FASHION SQUARE MALL MASTER PLAN AND DRI AMENDMENT

SUMMARY

<p>Updated: May 20, 2014</p>	<p>Master Plan approval to add multi family</p>

MASTER PLAN APPROVAL / DRI AMENDMENT AREA

Map H of Subject Area

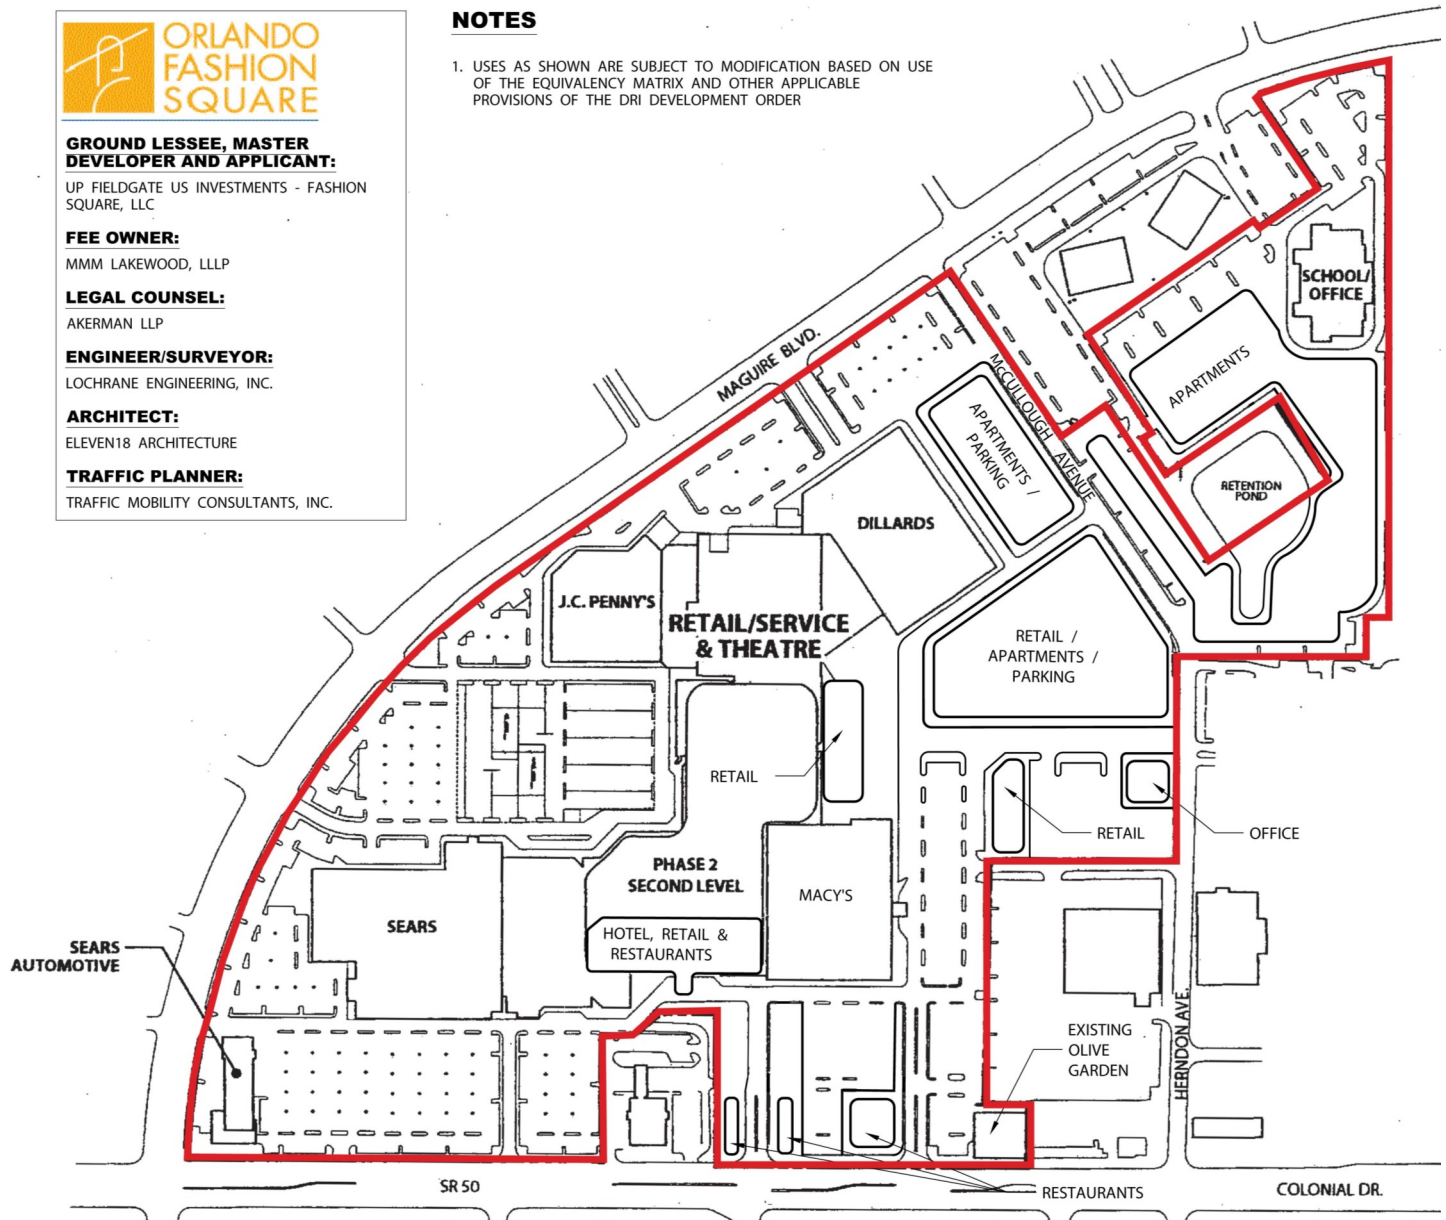
Below-Fashion Square Mall Development of Regional Impact (DRI) Map H.

The development program is proposed to be adjusted to introduce a residential land use and associated changes to Map H of the DRI. The proposed development program is summarized in Table 2 with a comparison to the approved development levels from Table 1.

It is evident that the changes to the DRI's development program result in an increase in the mall area of 87,611 SF, a decrease of 350 theater seats, and the addition of 593 multifamily residential units. A corresponding increase in parking of 1,134 spaces is necessary to accommodate the modified program.

PROPOSED STREET CROSS SECTIONS

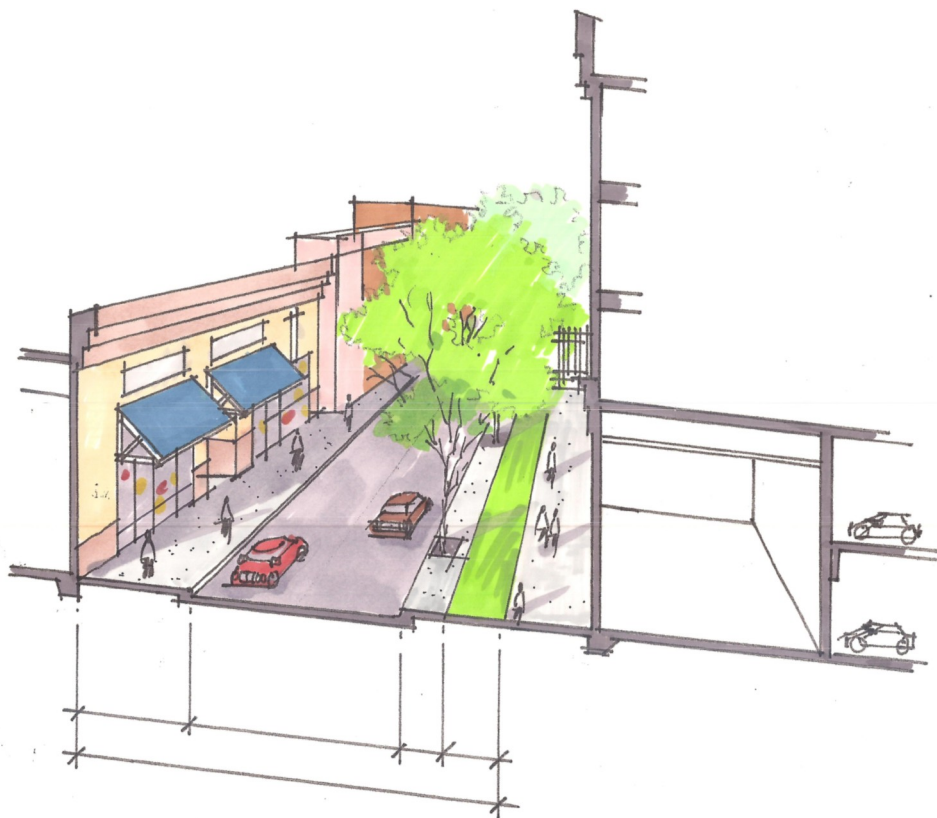
2. BICYCLE AND PEDESTRIAN TRAIL REQUIREMENT: The "Section C" roadway cross section shall be revised to move the bicycle/pedestrian trail four (4) feet away from the curb and any lateral structures (FDOT PP Manual 8.6.10 & 8.6.5). The bicycle and pedestrian trail path shall not contain any street furniture or landscaping in order to maintain a ten (10) foot clear path.

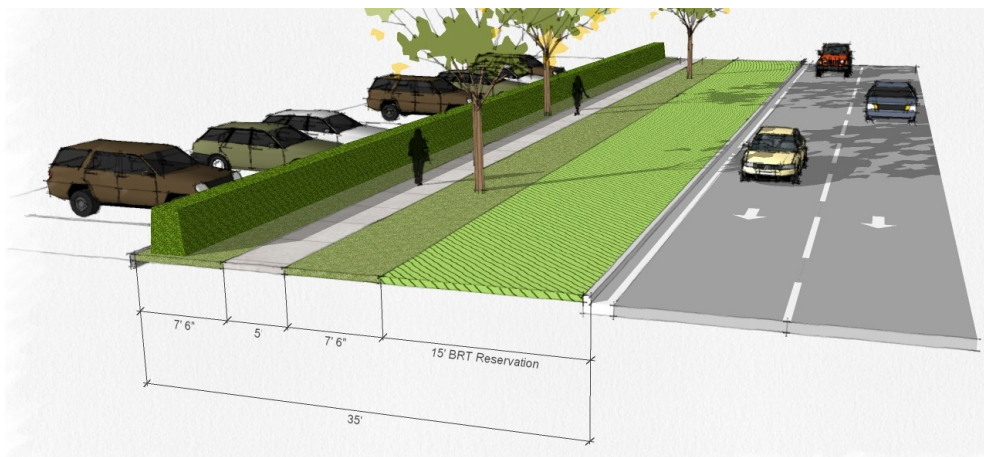
10. **CROSS-ACCESS CORRIDOR REQUIREMENTS:** The subject property is adjacent to a major thoroughfare, Colonial Drive. Orlando Land Development Code (LDC), Chapter 61 (Sections 61.108 – 61.113), provides the minimum requirements for cross-access corridors. The subject development shall provide cross-access easements to the applicable adjacent properties to ensure that the parking, access, and circulation may be easily tied in to create a unified system.
